REMARKS

Objections to Specification and Drawings

APPENDIX

Figure 1A

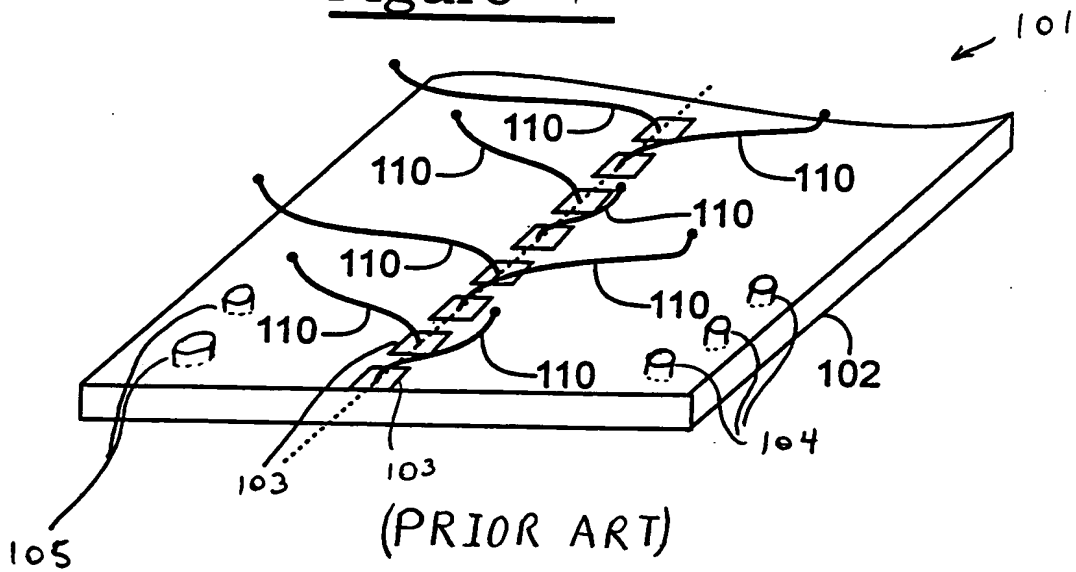
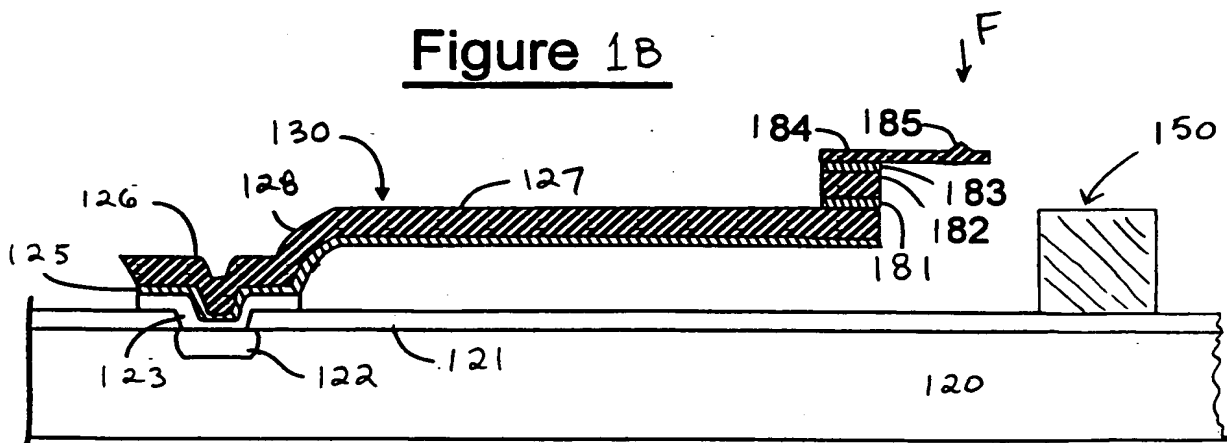
Additionally in the Office Action, the drawings were objected to for failing to show every feature of the invention as specified in the claims. Applicants respectfully submit that the drawings include all features recited in new claims 43-57. Further, as instructed by the Examiner, Figures 1A and 1B have been corrected in an accompanying Drawing Change Authorization Request (filed herewith) to include legends indicating that those drawings show prior art subject matter. In addition, Figures 2A-2D, 4, 6A, 6B, 6D-6G, 6I-6K, 7A, and 8A have been corrected in an accompanying Drawing Change Authorization Request to show cross-hatching of layers in respective sectional views. Figures 3D and 6C have been replaced with new Figures 3D and 6C by the Drawing Change Authorization Request. Applicants note that the Office Action objects to Figures 9A-9D based on the "insulative" and "conductive" layers not being cross-hatched. Applicants respectfully submit that Figures 9A-9D represent an alternative process for forming the resilient contact element of the present invention by showing a mold (901) and a deformable material (903) deposited on a substrate (905). All features in Figures 9A-9D are shown in section and are cross-hatched accordingly. Applicants respectfully submit that the drawings and specification are in good form for allowance.

OK
SN
6/8/01

OK
SN
6/8/01

FIG. 2C

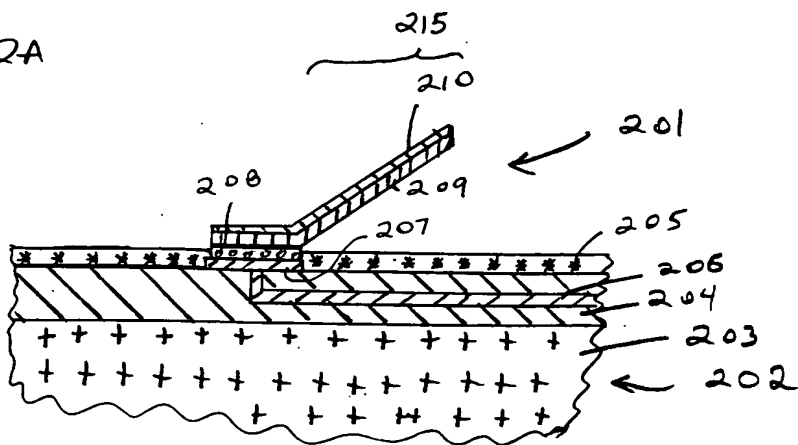
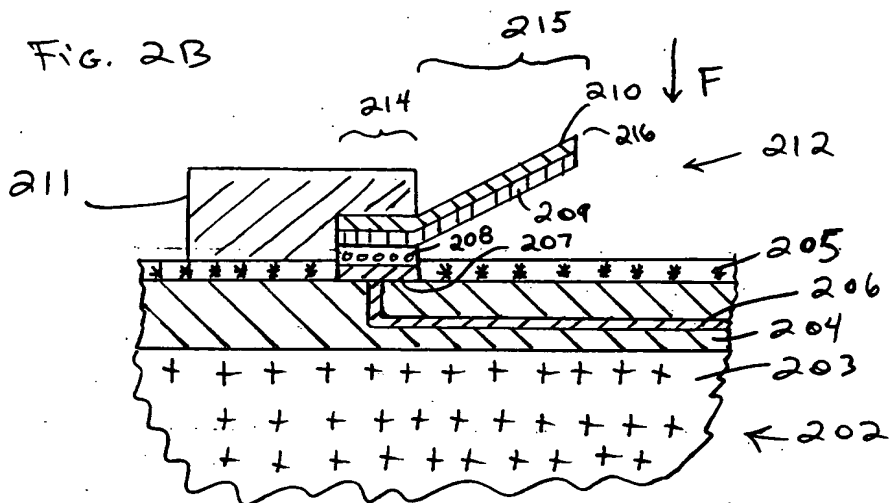
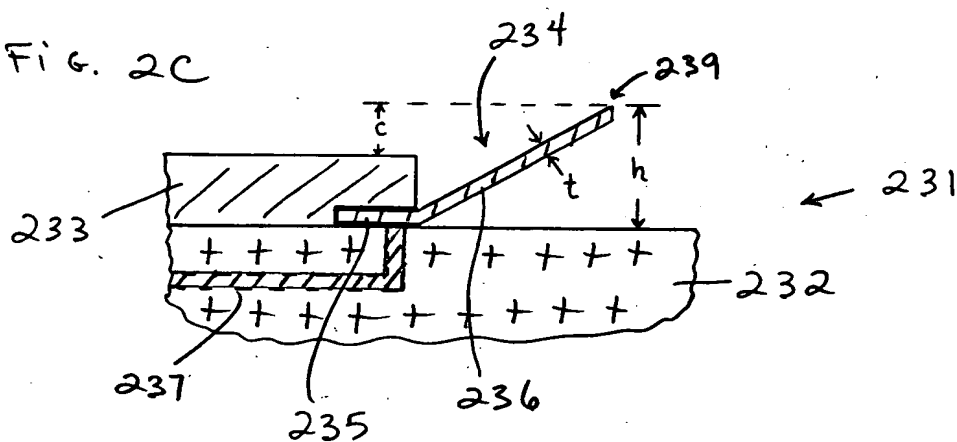
NOT OK (AL)
SN
6/8/01

NOT OK
6/8/01
SN

FIG. 3C

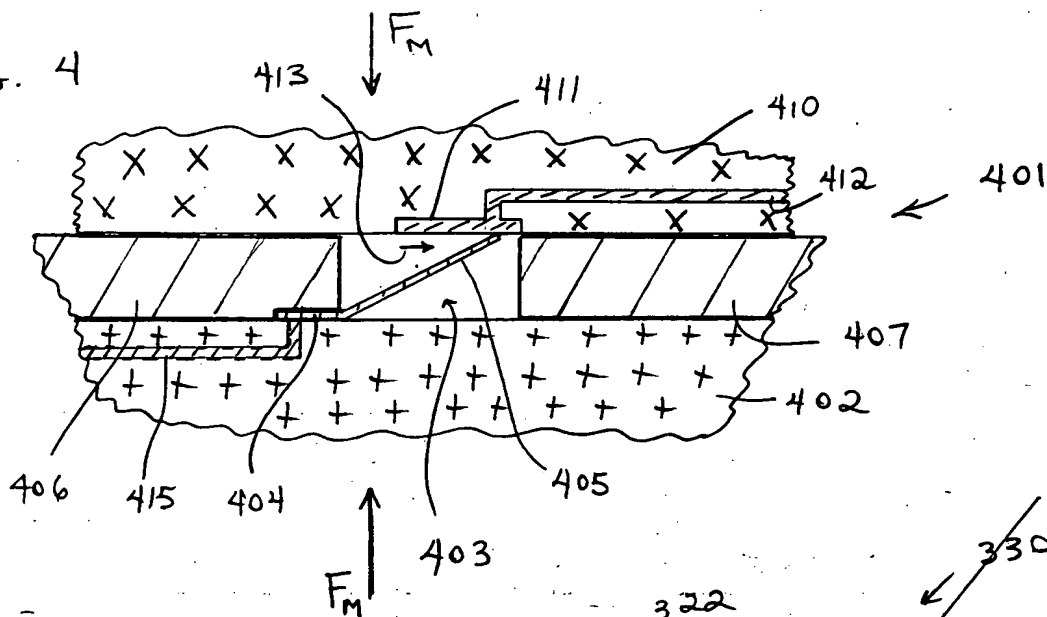
NOT OK
6/8/01
SM

FIG. 6D

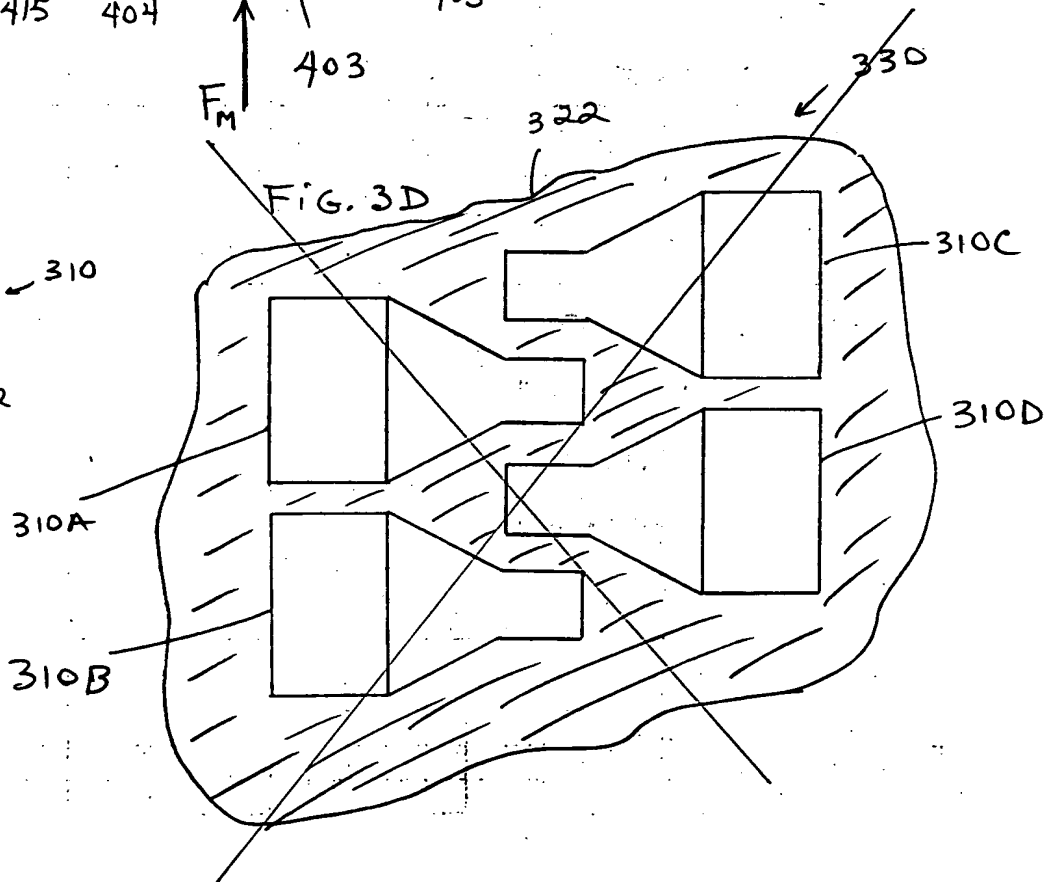
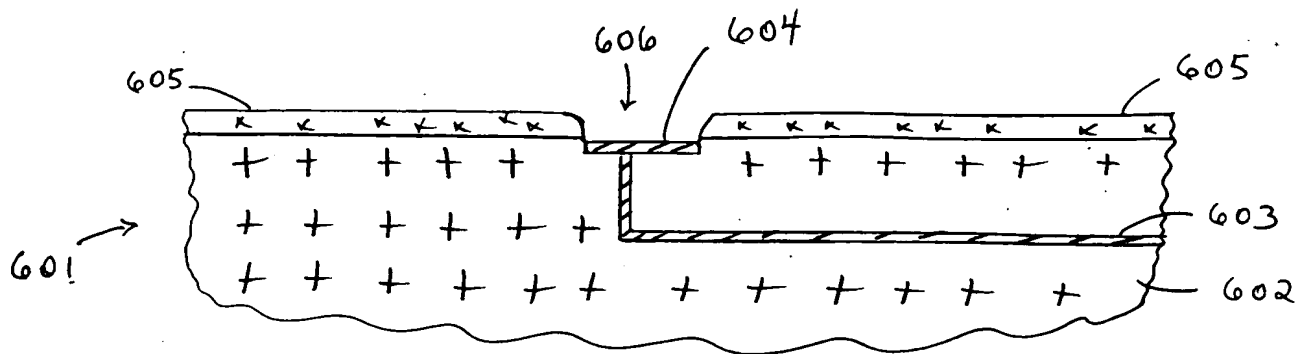
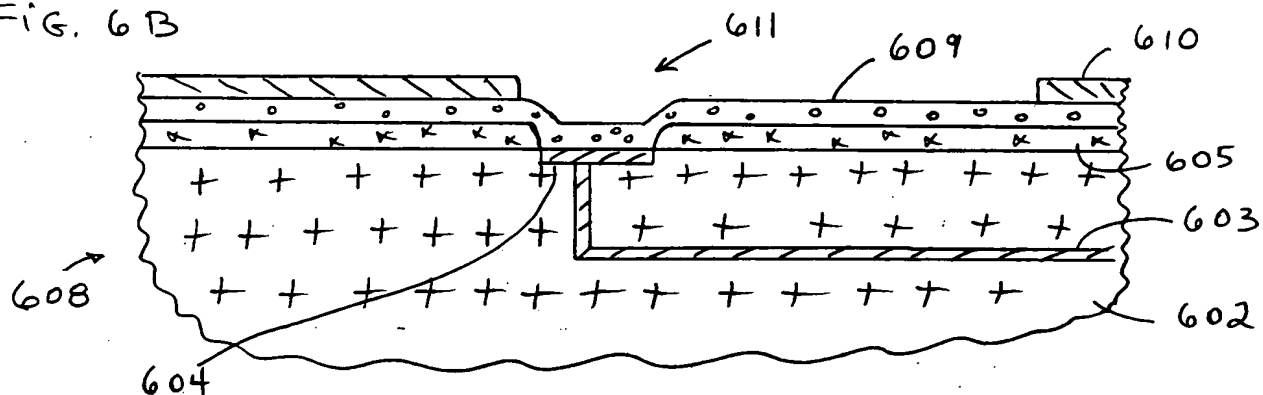
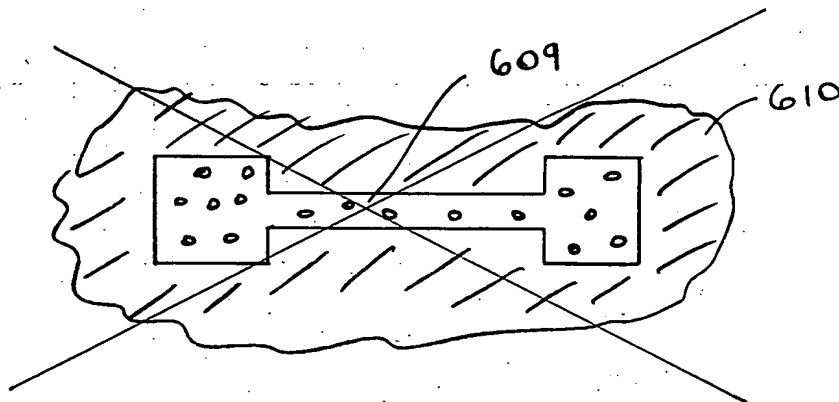
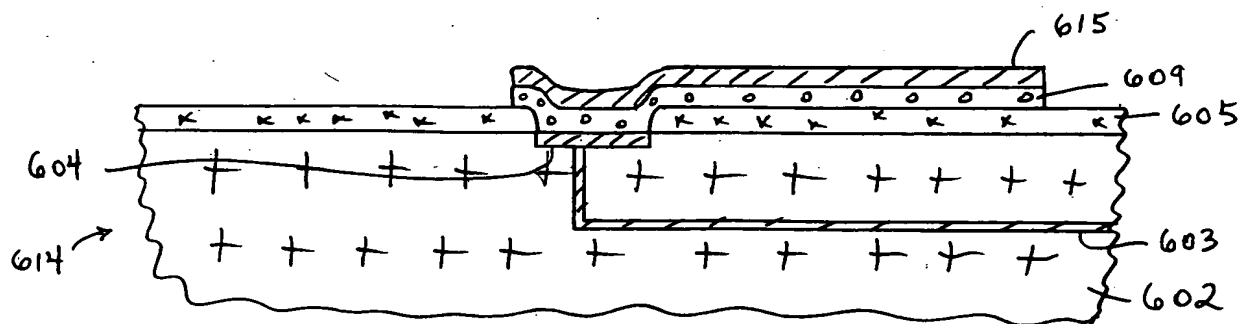
NOT OK (ALL)
6/6/01
SW

NOT OK (ALL)
6/8/01
SN

FIG. 6K

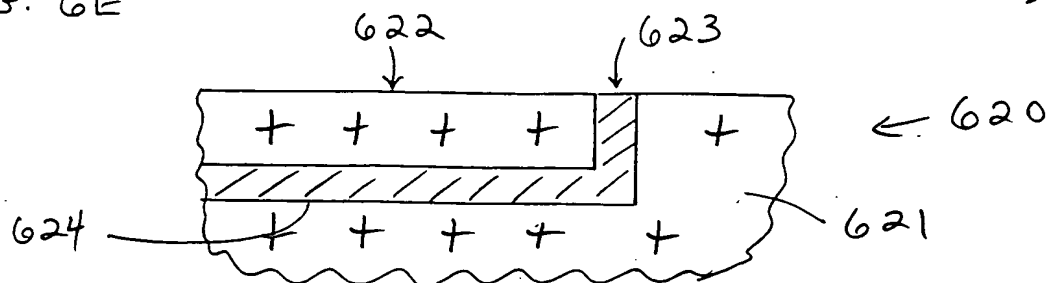
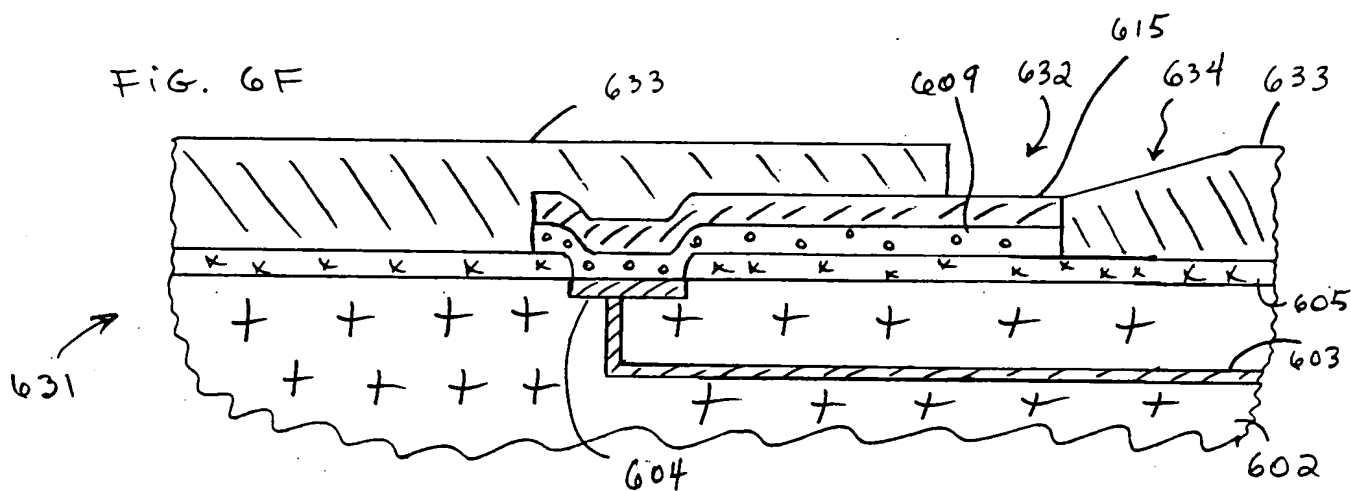
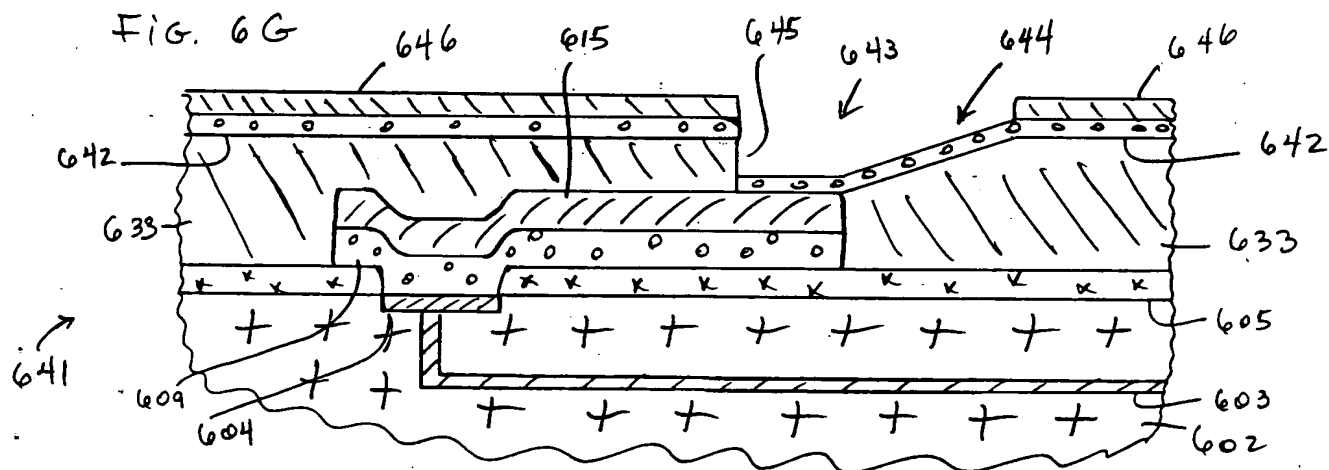
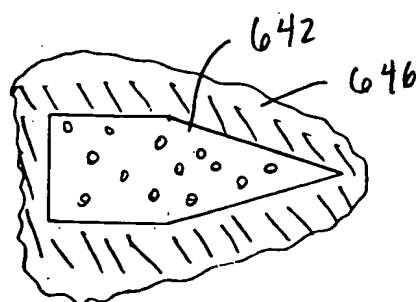
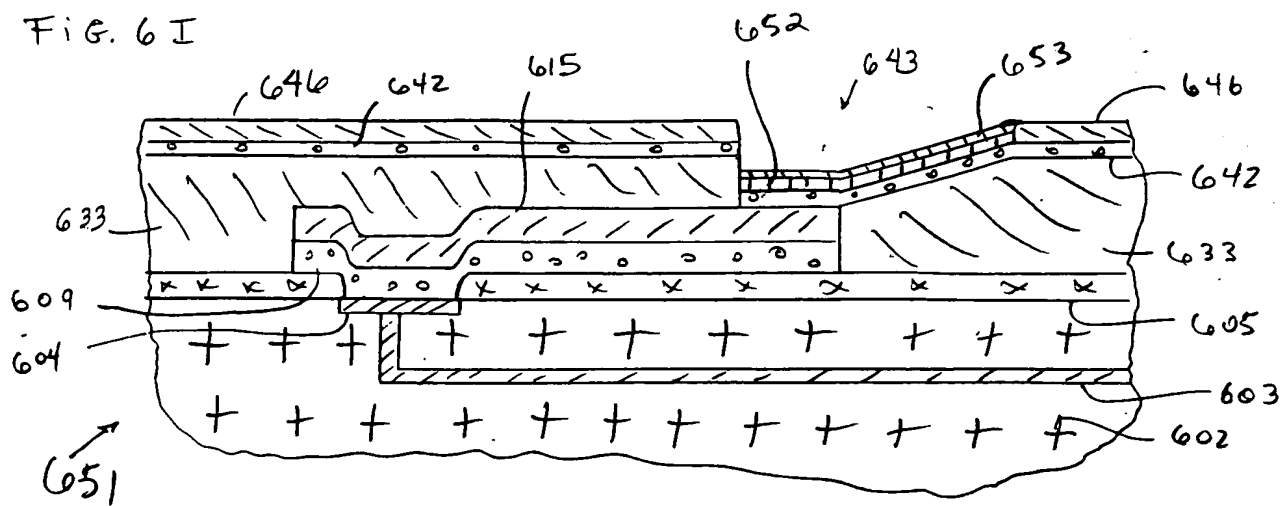
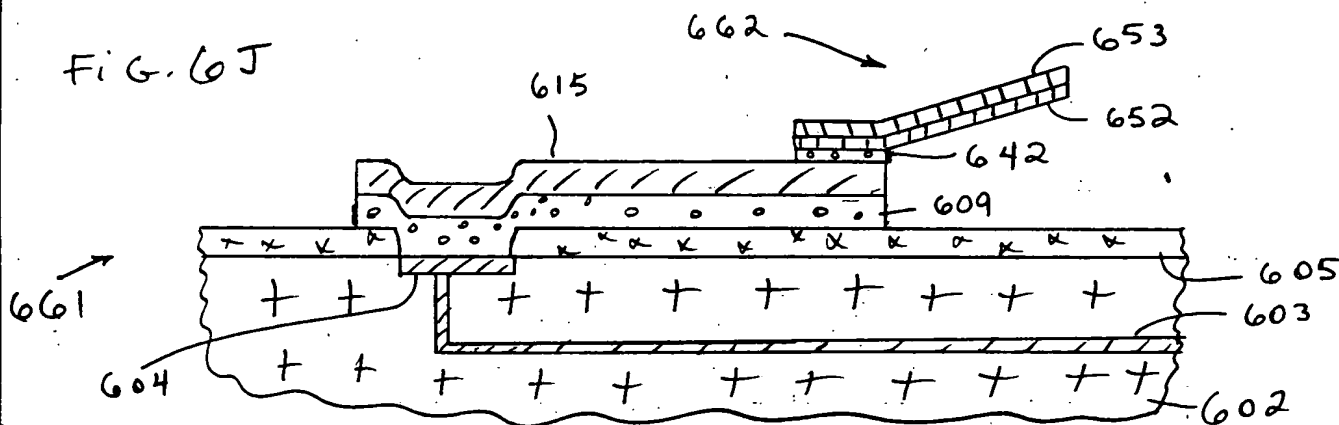
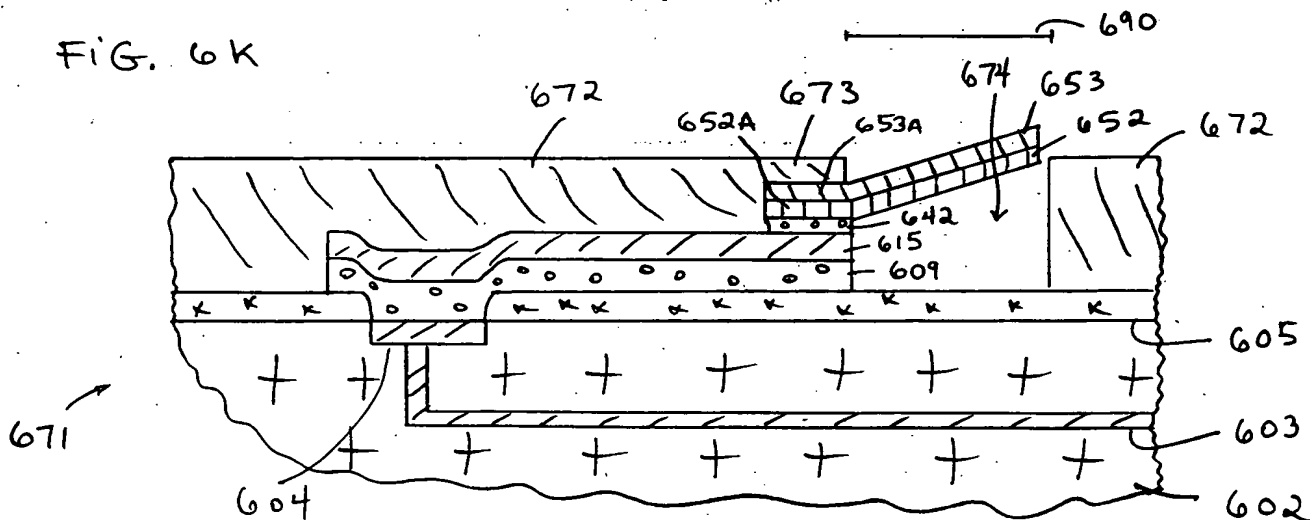
NOT OK (ALL)
6/8/01
SN

NOT OK
6/8/01
SN

NOT OK
6/8/01
SN

Fig. 3D

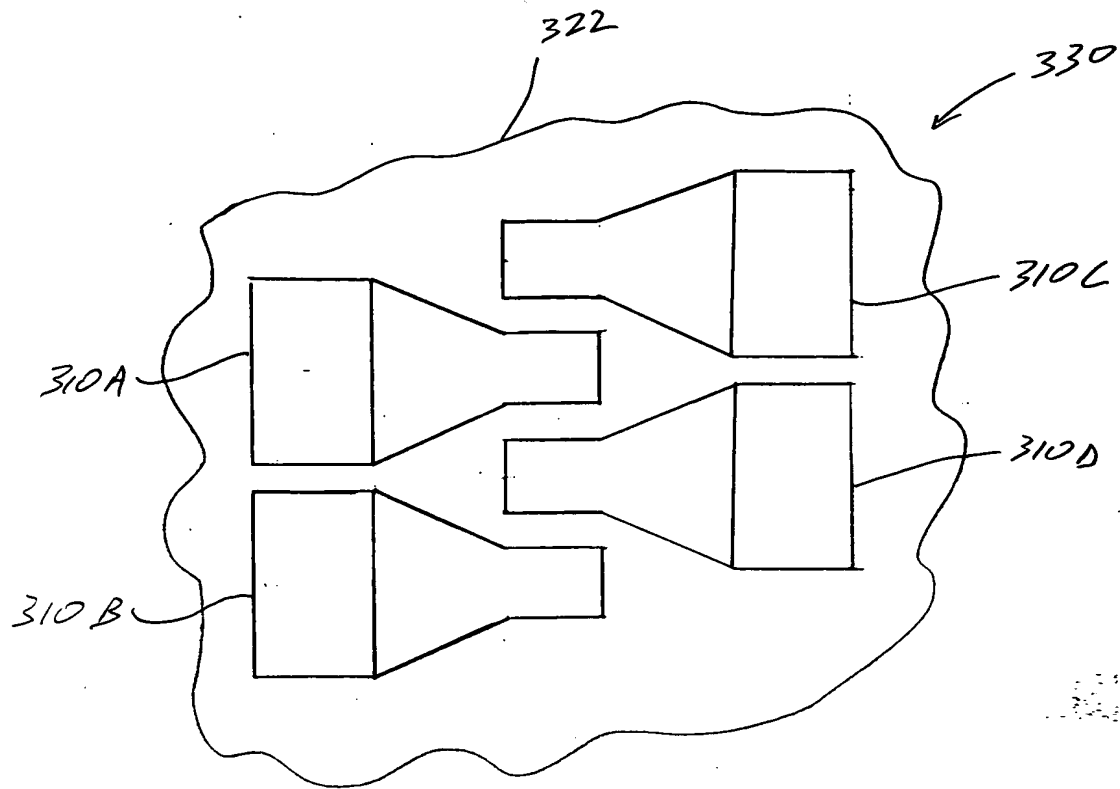
OK
6/8/01
SN

Fig. 6C

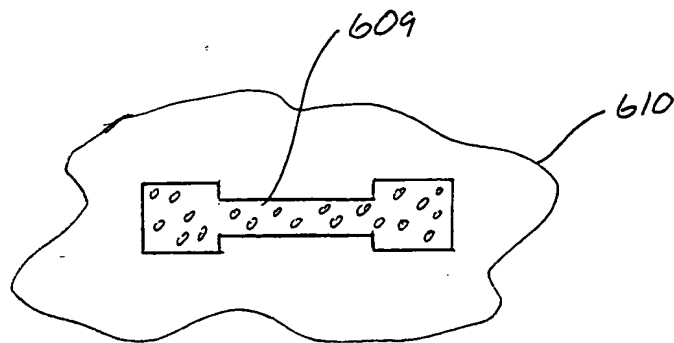
OK
6/8/01
SN
